MASTER REVIEW REPORT

CASE NUMBER: C814-2026-0001

PROJECT NAME: Town Lake YMCA PUD

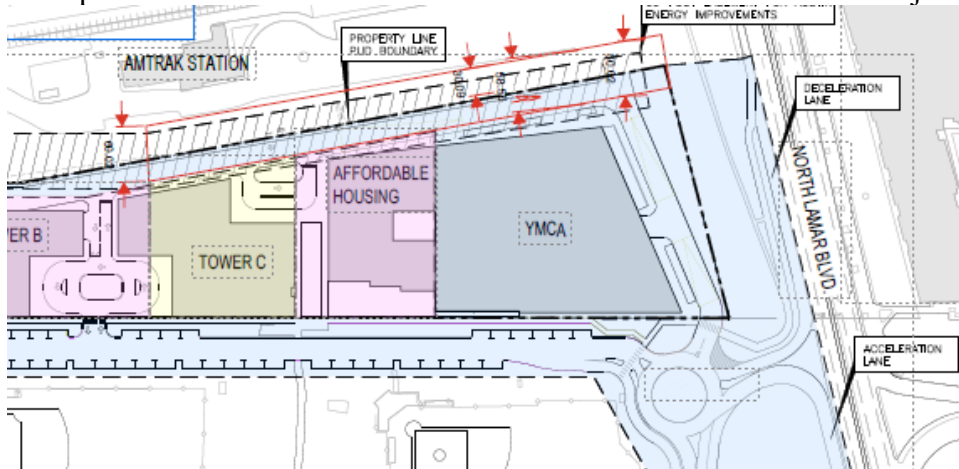
- EL 1. AE transmission lines will need to be relocated due to this YMCA Town Lake redevelopment project. The YMCA shall procure a 60' wide easement from all affected landowners once the transmission route is finalized and convey to City of Austin at no cost to AE, at least 6 months prior to AE construction of the transmission line.

- EL 2. Easement locations are not final until the design is at 60% for transmission. All future transmission/distribution easements are not locked in place yet. More easements not currently shown will be needed for distribution lines and vaults.

- Pole locations typically fall in/near the centerline of the easement for safety setbacks and would be coordinated with the overall design of the site during our design process. The shown preliminary easement layout in the plans may not be the actual acquired easement. On the Land Use Plan- the final easement shall extend east to the Lamar right of way. There should be no gap between easement and existing ROW. Update the Land Use Plan and note that the easement shown is subject to changes.

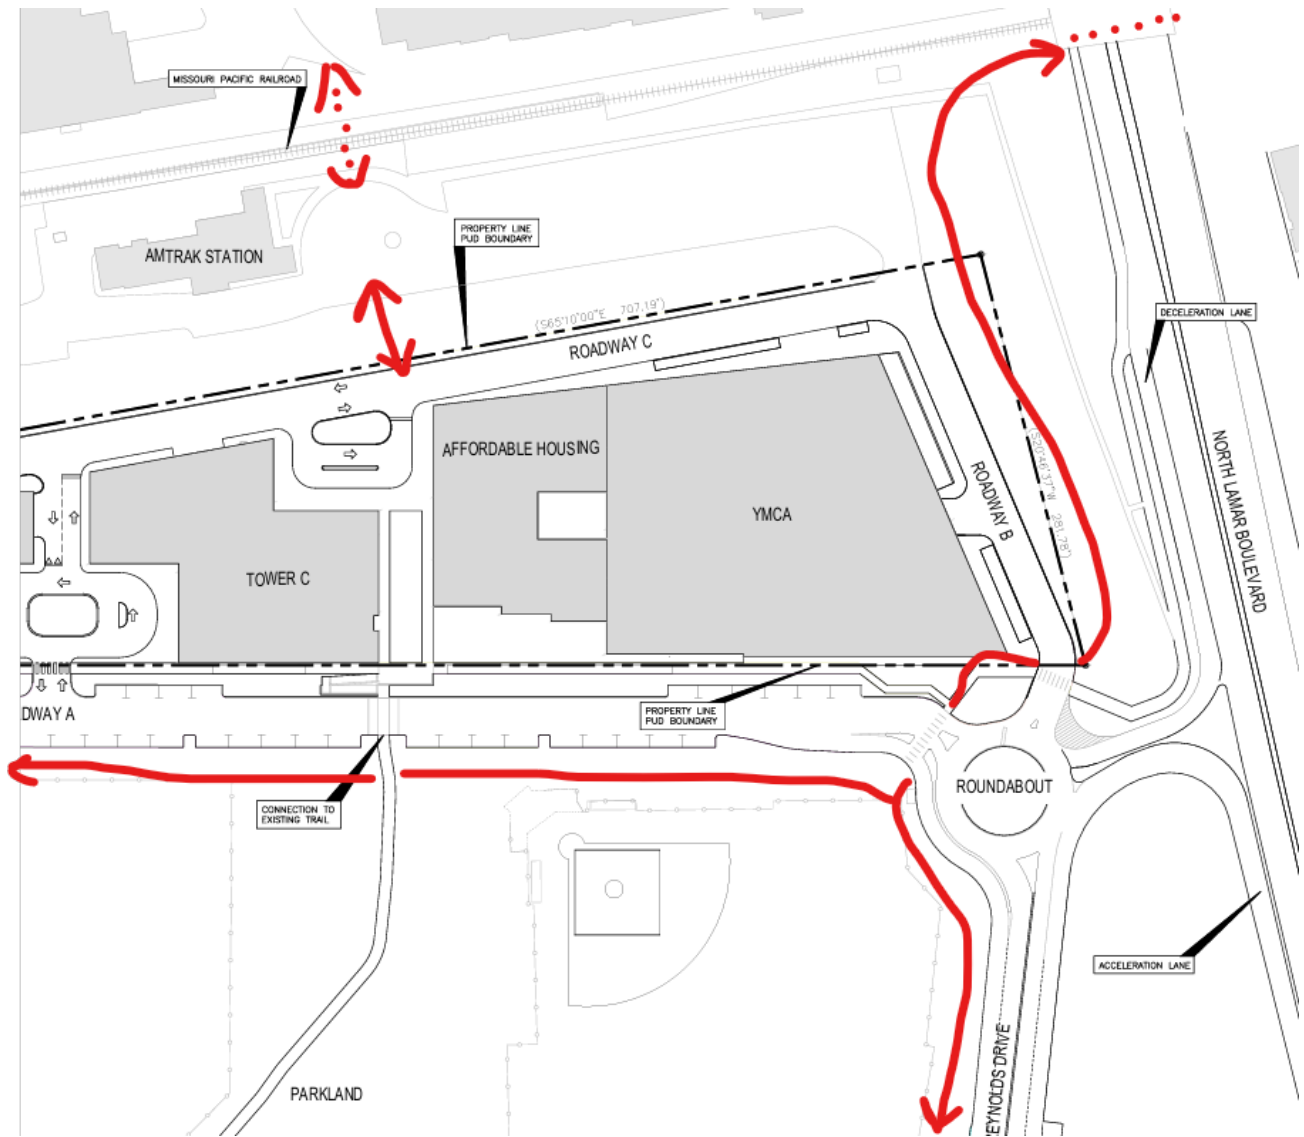
Comment pending final TIA recommendations. ATPW also recommends the provision of a 12' shared use path (SUP) along BR Reynolds Drive (or equal N-S connection). This SUP would connect the Lance Armstrong Bikeway to 3rd Street. This is a Tier 1 priority as identified in the Urban Trails Plan.

An east-west bike/ped facility is also recommended along the southern boundary of 'Roadway A' to provide for a connection to hike and bike trail and Austin Pets Alive facility. Additionally, ATPW recommends the provision for additional pedestrian access to the Amtrack station/Baylor Street via passage between Tower C and the YMCA.

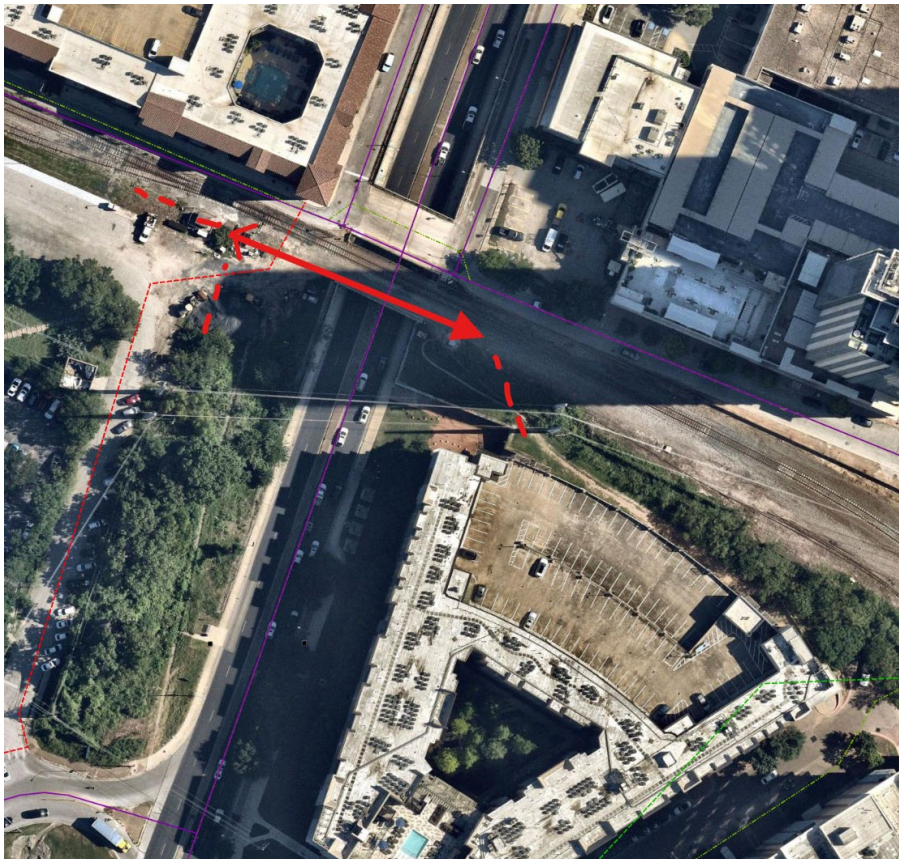
ATPW does not support this request. Substantive changes to land uses may significantly alter traffic patterns and peak hour operations. We recommend removing this note completely and deferring to standard practice of TIA compliance/amendments at the time of site plan as needed. If additional entitlement (+15% vtd) is sought, it should be requested and evaluated at this time.
